**1RF-478 ZEUS
CONTAINMENT,
FACILITY ID
[fVV2203339361]
Variance Request
Burial in Place/OCD
Certified Letter**

RE: [371643] Solaris Water Midstream, LLC - 1RF-478, ZEUS CONTAINMENT, FACILITY ID [fVV2203339361]

RE: Solaris Water Midstream, LLC, Zeus, Zeus Deuce & Zeus Tres Containments

RESPONSE to COST ESTIMATE DENIAL for Zeus III and III**Randall Hicks**

Selected Cross Sections of Zeus I, II, III Containments

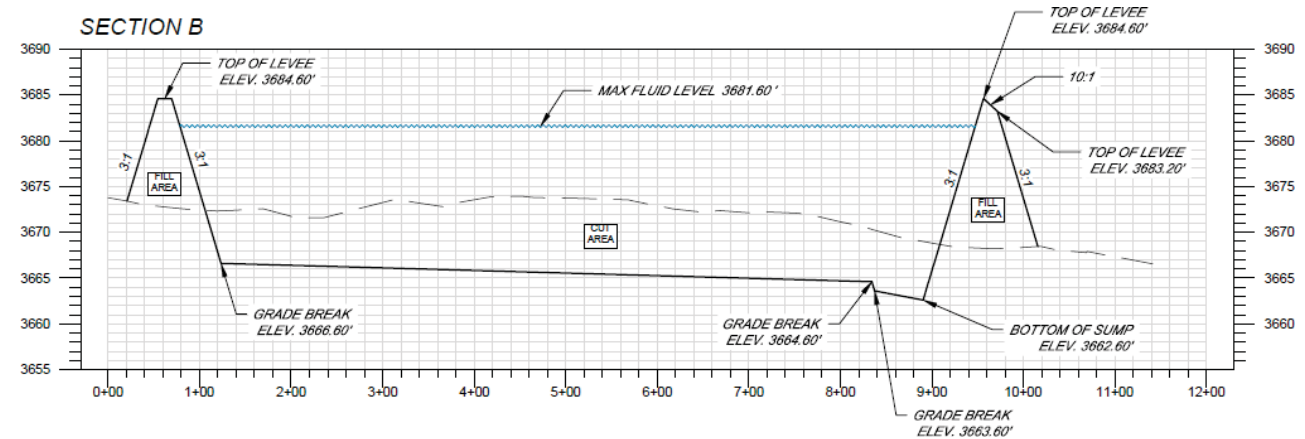
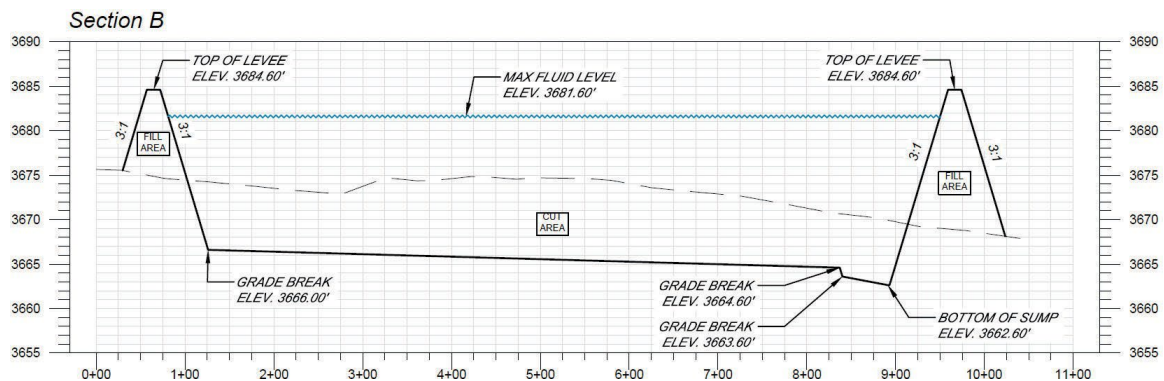
The cross sections from the engineering plans for the Zeus I, II and III containments, presented below, demonstrate that burial at or below the prescribed depth is practical. Limited excavation to ensure the depth of burial may be necessary.
